UNITED STATES
DEPARTMENT OF THE INTERIOR
BUREAU OF LAND MANAGEMENT
SUNDRY NOTICES AND REPORTS ON WELLS

8. Well Name and No.
Cotton Draw Unit 114

9. API Well No.
30-015-37410

RE: Flex Hose – Conditions of Approval

H&P 214

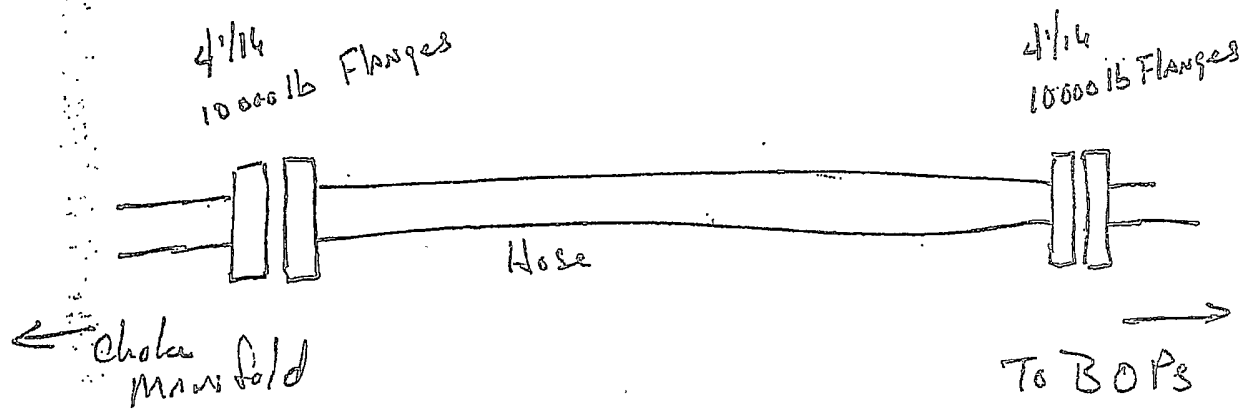
~~Choke~~ Choke here

13-5/8" x 5,000 psi BOP Stack

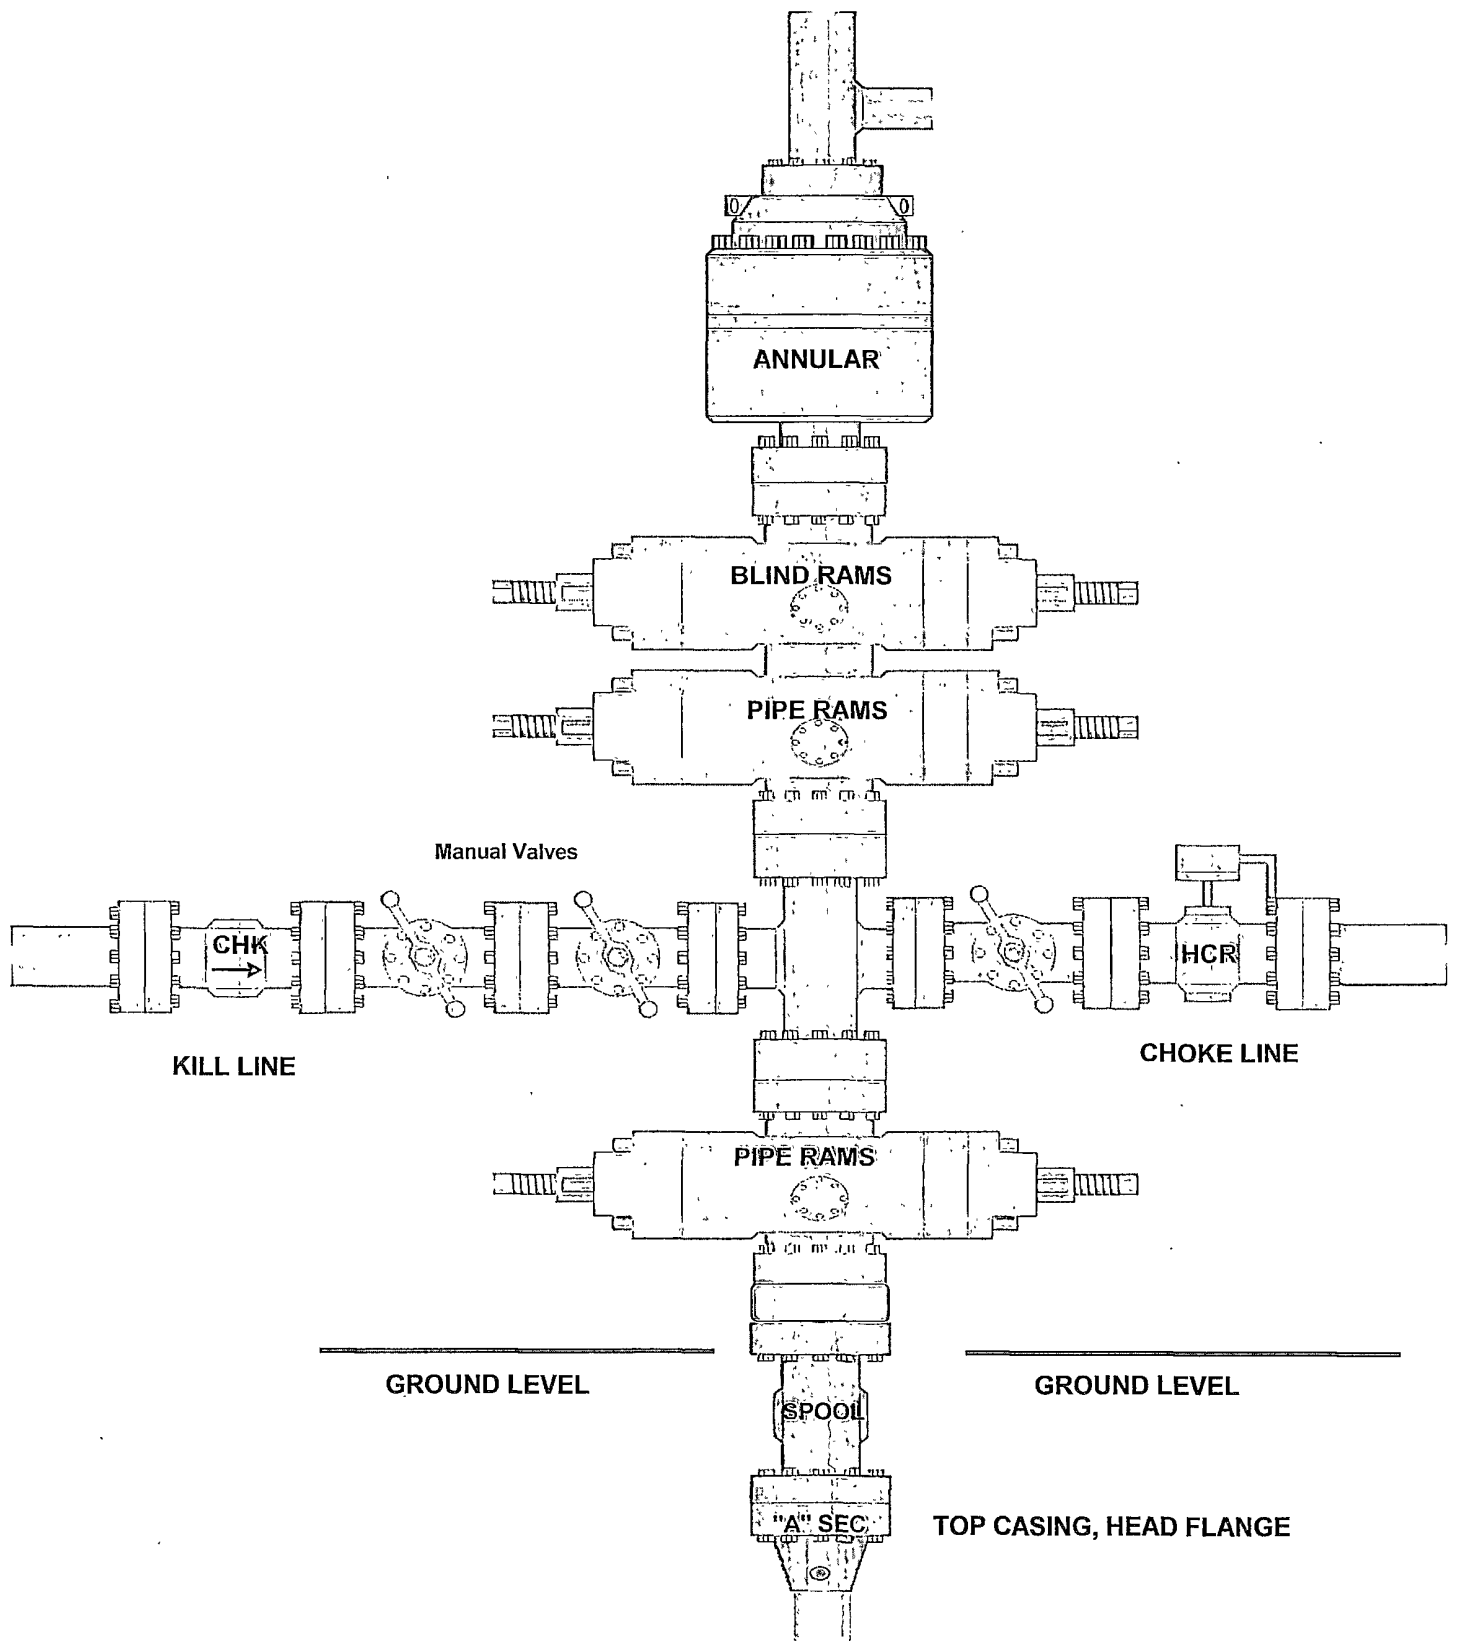
Devon Energy Production Company L. P. respectfully requests to change the rig layout from the McVay 8 to H & P #212 to drill this well and requests a variance that a co-flex hose may be used between the BOP and the choke manifold. The hose will be kept as straight as possible with minimal turns. CO-Flex Hose Manufacturer: Phoenix Beattie; ~33' (11.43 meters) of co-flex line; 3" coupling 2/4 1/16" flange on each end, 10,000 psi; Quality Control Inspection & Test Certificate attached; see configuraton schematic. Safety clamps are not required since the ends are flanged.

Variance approved to use flex line from BOP to choke manifold. Check condition of 3" flexible line from BOP to choke manifold, replace if exterior is damaged or if line fails test. Line to be as straight as possible with no hard bends.
